3106
CONTINUUM SOUTH

MASTER CLOSET UPDATE

DESIGN CONCEPT

A - 02

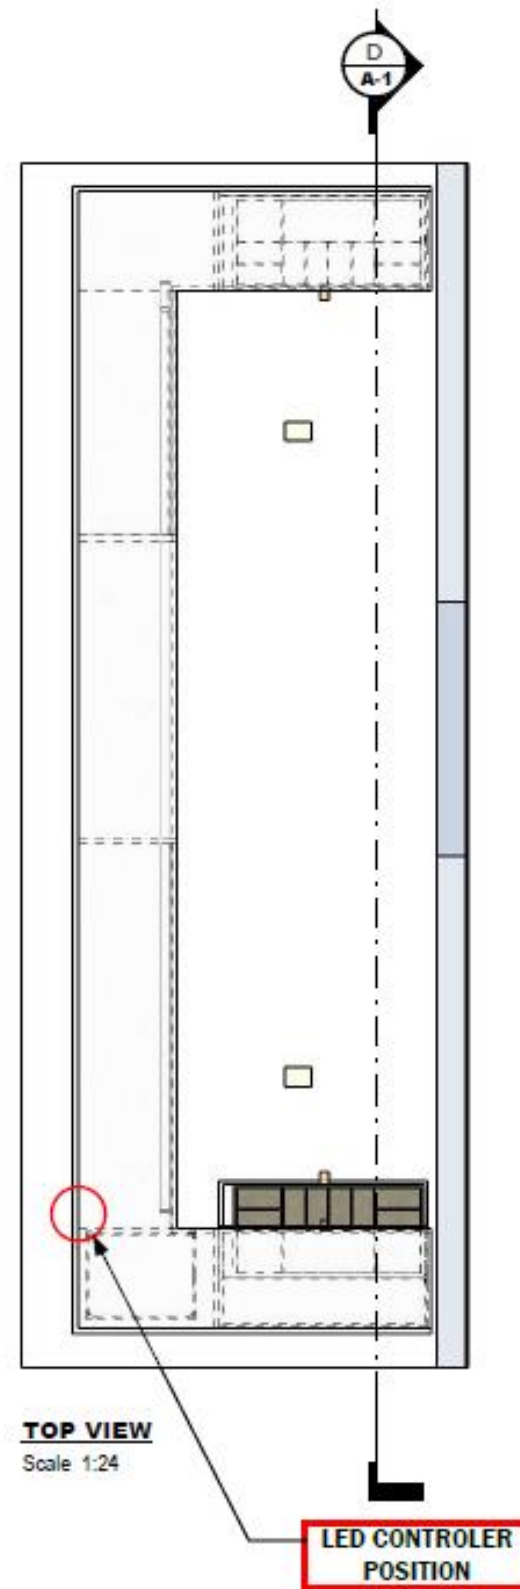
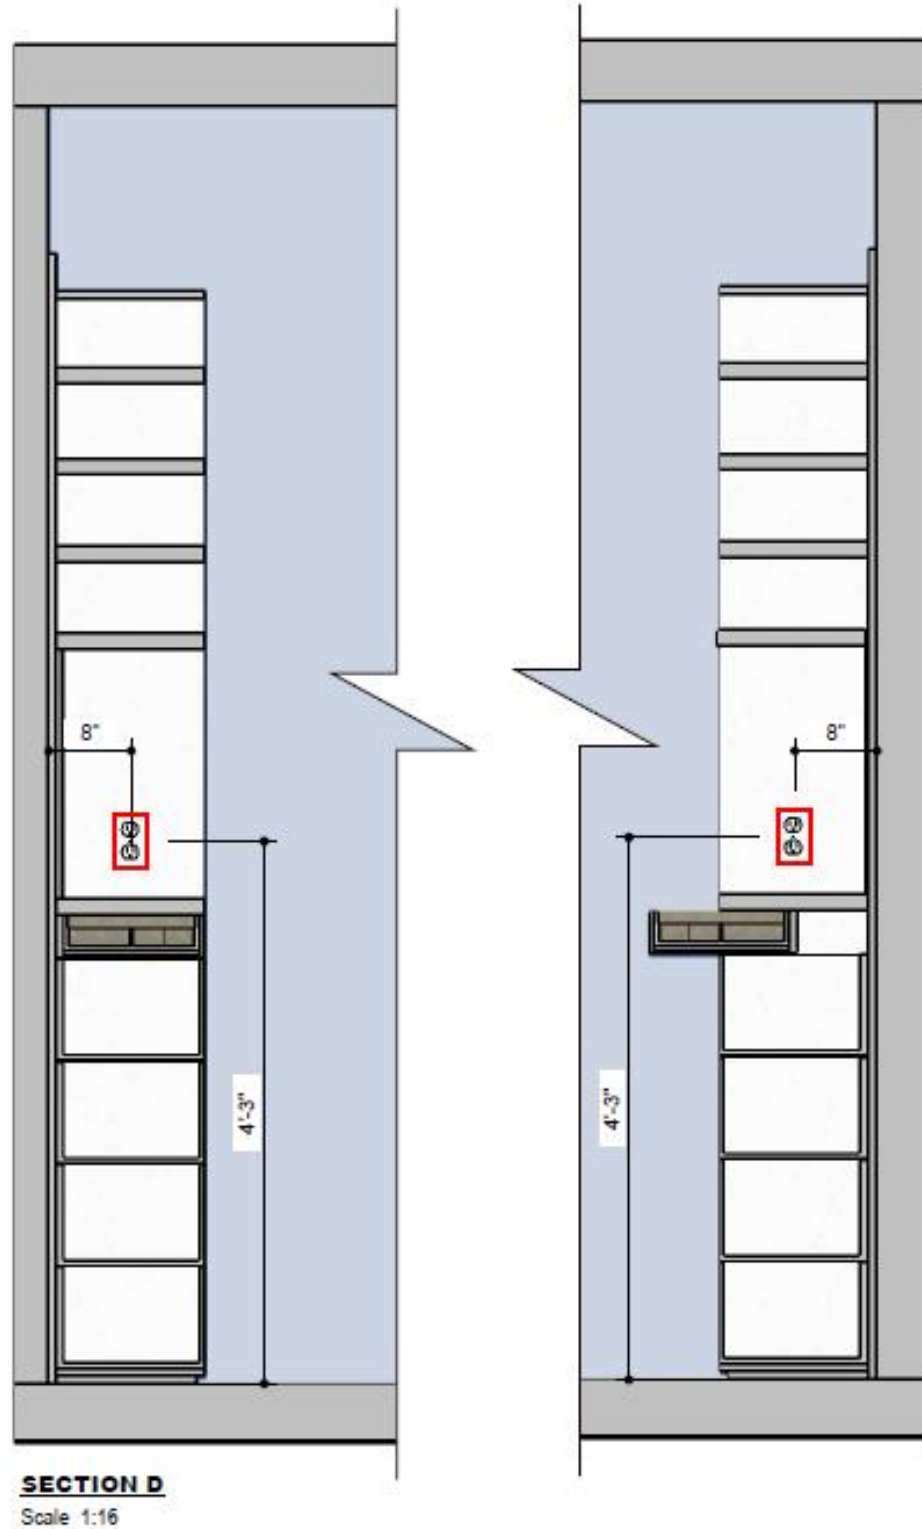
DUE TO THE ACTUAL MEASUREMENT OF THE CEILING HEIGHT AND THE DIMENSIONS OF THE DROP CEILING, IT WAS NECESSARY TO READJUST THE DESIGN. THIS INVOLVE REMOVING THE UPPER SECTION, LEAVING THE 18 INCHES FOR LUGGAGE STORAGE, AND ADJUSTING THE SHORT CLOTHING SECTIONS TO THEIR CONVENTIONAL HEIGHT OF 40 INCHES. WE NEED ANY SUGGESTION OR APPROVAL IN CASE ANY FURTHER ADJUSTMENTS ARE NOT REQUIRED.
